ZONING AMENDMENT,
PLANNED UNIT DEVELOPMENT,
PLANNING APPROVAL &
SUBDIVISION STAFF REPORT

Date: October 18, 2007

<u>NAME</u>	James S. McAleer
<u>SUBDIVISION NAME</u>	J & D Subdivision
<u>LOCATION</u>	3305 Spring Hill Avenue (East side of Ingate Street, extending from Spring Hill Avenue to Old Carline Street)
<u>CITY COUNCIL DISTRICT</u>	District 1
<u>PRESENT ZONING</u>	B-1, Buffer Business, and B-3, Community Business
<u>PROPOSED ZONING</u>	B-3, Community Business
<u>AREA OF PROPERTY</u>	1 lot / 1.6 ± Acres
<u>CONTEMPLATED USE</u>	<p>Subdivision approval to create one lot, Planned Unit Development Approval to allow increased site coverage, <i>Planning Approval to allow heavy warehousing (exceeding 40,000 square feet in a B-3 District)</i>, and Rezoning from B-1, Buffer Business, and B-3, Community Business, to B-3, Community Business, to eliminate split zoning in a proposed commercial subdivision.</p> <p>It should be noted, however, that any use permitted in the proposed district would be allowed at this location if the zoning is changed. Furthermore, the Planning Commission may consider zoning classifications other than that sought by the applicant for this property.</p>

SITE PLAN

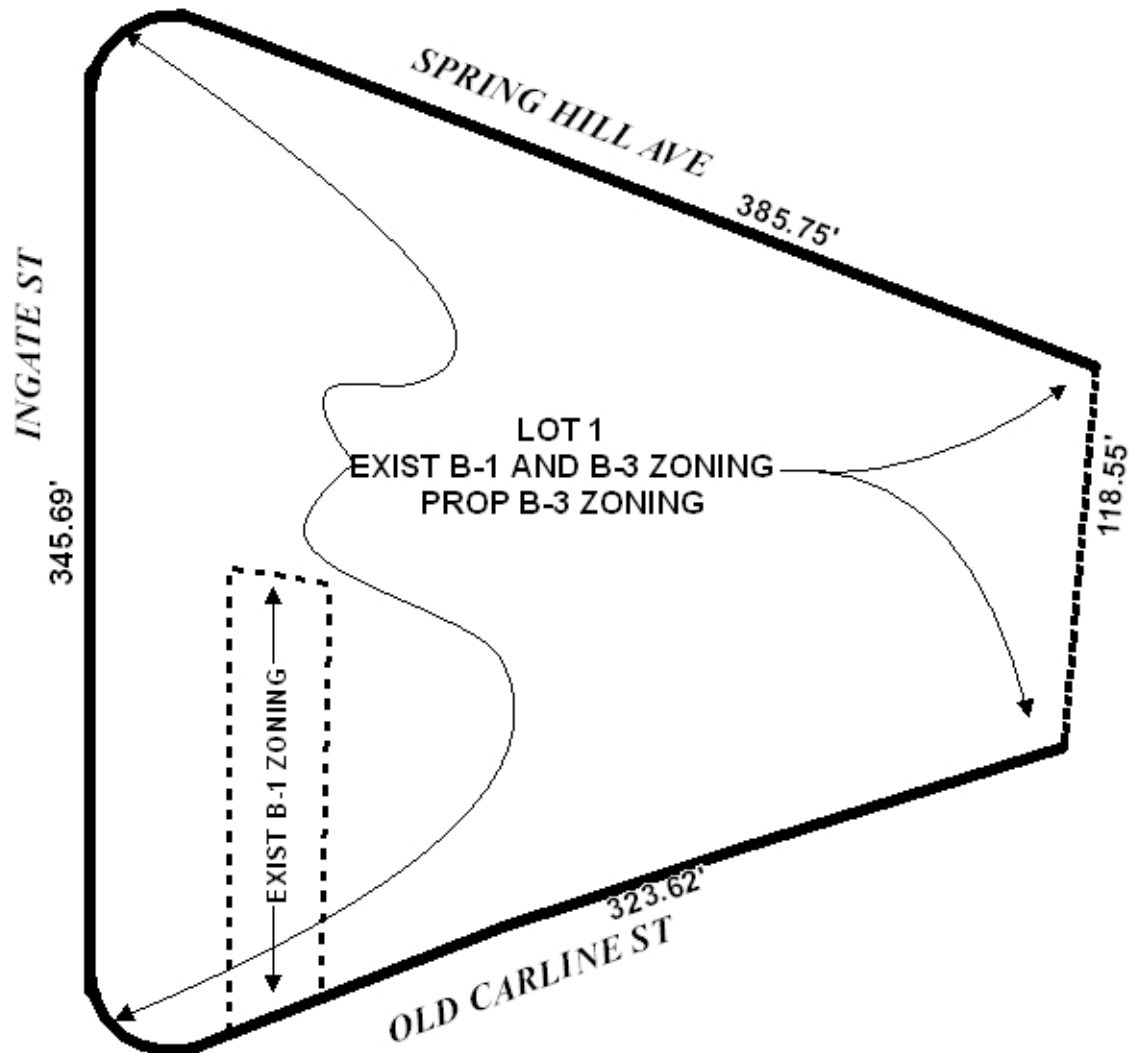
The proposed site/layout plan indicates that the proposed addition will be on the Ingate and Carline portion of the site, and that a parking area will access Ingate Street, while the existing development will continue to utilize access to Spring Hill Avenue and Old Carline Street. The

site currently has one curb-cut onto Ingate Street, however the size of the existing curb-cut is not sufficient for commercial use, and it appears to serve a graveled parking area, which does not comply with the Zoning Ordinance.

The existing development has no on-site access from the front to the rear of the property, and the proposed new development will not facilitate movement on the site in terms of on-site circulation. Ten parking spaces are proposed, however, as part of the development. All existing loading areas for the site also appear to require use of the public right-of-way by trucks to execute the turning movements necessary to access the existing building.

No on-site storm water detention facilities are depicted on the site plan, however such facilities may be required due to the extent of the proposed new development. After consultation with the Engineering Department, the site plan should be revised to depict any required on-site storm water detention facilities.

There is no indication on the site plan as to the proposed location of any dumpster or other waste storage facility. Visual inspection of the site indicates that dumpsters are located on the Southeast corner of the property, and are currently unscreened. The location of the storage area for the dumpster must be indicated on the site plan, and the location and required screening must comply Section 64-4.D.9. of the Zoning Ordinance, as well as with all other applicable regulations.

The site plan should also be revised to depict the existing parking and vehicular circulation for the remainder of the site.

The site plan implies that the western-most curb-cut on Spring Hill Avenue is continuous, however aerial photos indicate that its width is limited: if its width exceeds a typical width for two way traffic flow, the size should be reduced to a width acceptable to Traffic Engineering. The site plans (Zoning, PUD, and requested Planning Approval) should be revised to accurately depict existing curb-cuts that will remain, as well as any proposed curb-cuts.

The revised site plan depicts existing trees and proposed trees and landscaping on the site. 29 proposed trees are depicted (28 listed in the table on the plan), one of which is shown at the corner of Ingate Street and Springhill Avenue, where right-of-way will be dedicated: this tree should be moved to where it will not create a visibility hazard, perhaps to the green space between the existing parking area and the proposed parking area. The perimeter calculations by staff indicate that approximately 36 trees may be required to comply with the tree requirements, however, two large existing live oaks (one of which will be in the right-of-way upon corner dedication, and the other which is on the right-of-way line) may reduce the total number of trees. Compliance with the tree and landscaping requirements of the Zoning Ordinance should be coordinated with Urban Forestry.

The site plan also shows that the site has 3 existing curb-cuts onto Springhill Avenue, 2 existing curb-cuts onto Car Line Street, and 1 existing substandard curb-cut onto Ingate Street (that is proposed to be replaced with a 24-foot wide curb-cut for the proposed new parking area). The site should be limited to the existing curb-cuts along Springhill Avenue and Car Line Street, and the 1 proposed curb-cut onto Ingate Street, with the size, design and location to be approved by Traffic Engineering and in compliance with AASHTO standards.

The site has 16 existing parking spaces, and an additional 10 spaces are proposed in a new parking area that will be accessed from Ingate Street. The site plan states that 1,600 square feet of the building area will be for office use (requiring 6 parking spaces), and that an additional 6 spaces will be required for warehouse employees, for a total of 12 “required” spaces. The site plan depicts 26 spaces. It should be noted that about half of the existing parking area clearly does not meet the parking dimensional requirements for maneuvering areas, however, no changes should be required unless the applicant can provide additional “standard” parking in the proposed new parking area, and replace some of the existing parking with landscape area: it appears that about 7 spaces could be shifted from the existing parking area to an expanded new parking area. If parking is shifted from the existing area to the new parking area, the existing parking maneuvering area should be marked to create one-way circulation from West to East.

- 1) Submittal of an application for Planning Approval due to the warehouse portion of the operation exceeding 40,000 square feet;
- 2) Consultation with Engineering Department, and revision of the site plan to depict required storm water detention facilities;
- 3) Revision of the site plan to depict existing and proposed dumpster storage locations, in compliance with Section 64-4.D.9. of the Zoning Ordinance;
- 4) Revision of the site plan to depict existing on-site circulation and parking;

- 5) Placement of a note on the site plan stating that lighting shall be so arranged that the source of light does not shine directly into adjacent residential properties or into traffic;

- 8) Revision of the site plan to accurately depict all existing curb-cuts, and modifications thereof (with reduction of excessive width curb-cuts where possible), as well as proposed curb-cuts;

- 9) Revision of the site plan to provide frontage trees and landscaping along Spring Hill Avenue, where possible; and
- 10) Revision of the site plan and plat to depict the 25-foot minimum building setback line for the entire site, adjusted as necessary to accommodate the right-of-way dedication for Old Carline Street, in compliance with Section V.D.9. of the Subdivision Regulations.

- 1) Application for a parking ratio variance, and approval of the request by the Board of Adjustment prior to the issuance of building permits;*
- 2) Compliance with the tree and landscaping requirements to be coordinated with Urban Forestry;*

- 3) Relocation of the tree proposed at the corner of Ingate Street and Springhill Avenue to the green space located between the existing and proposed parking areas, so that visibility hazards are reduced;*

- 4) Revision, at the applicant's discretion, of the existing parking area to shift some parking to an expanded new parking area, and replacement of the shifted existing parking spaces with landscaping and directional arrows to create a one-way circulation in the existing parking area;*

- 5) Revision of the PUD site plan to show correct totals for parking and tree quantities;*
- 6) Placement of a note on the site plan stating that the site is limited to a maximum of 64% building site coverage;*

SITE PLAN

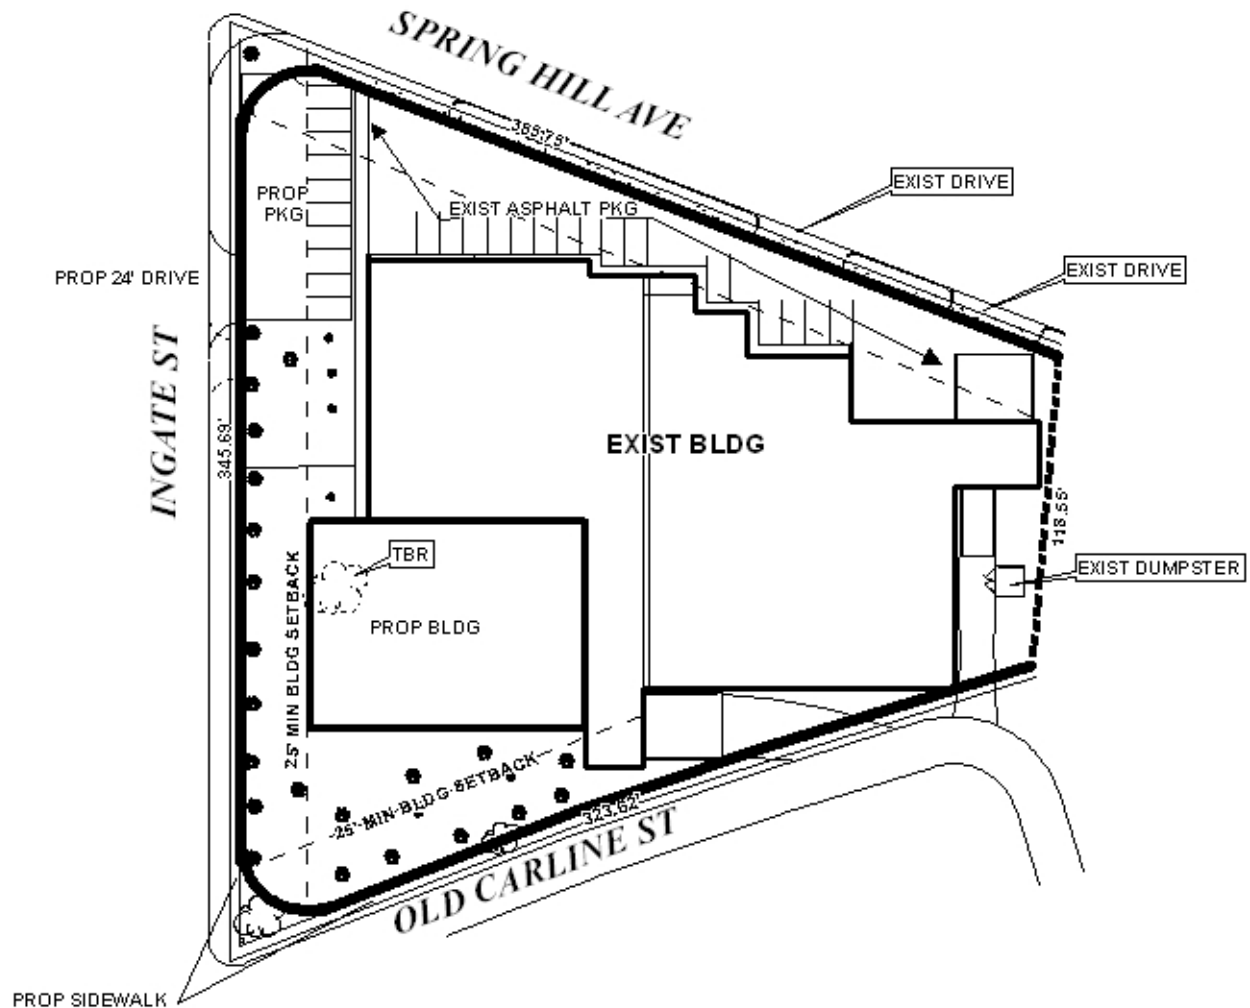
The site plans depict the 25-foot minimum building setback line from all street frontages, but the Subdivision plat does not show the required setback along Ingate or Car Line Streets. The plat should be revised to depict the required setback.

Both the site plan and plat show 25-foot corner radius dedications at Ingate Street and Springhill Avenue as well as at Ingate Street and Car Line Street.

- 1) *Depiction of the 25-foot minimum building setback line from all street frontages;*
- 2) *Placement of a note on the plat stating that the site is limited to 3 existing curb-cuts onto Springhill Avenue, 2 existing curb-cuts onto Car Line Street, and 1 proposed curb-cut onto Ingate Street (eliminating the existing curb-cut), with the size, design and location to be approved by Traffic Engineering and to comply with AASHTO standards; and*
- 3) *Provision of revised PUD and Planning Approval site plans to the Planning Section of Urban Development prior to the signing of the final plat.*
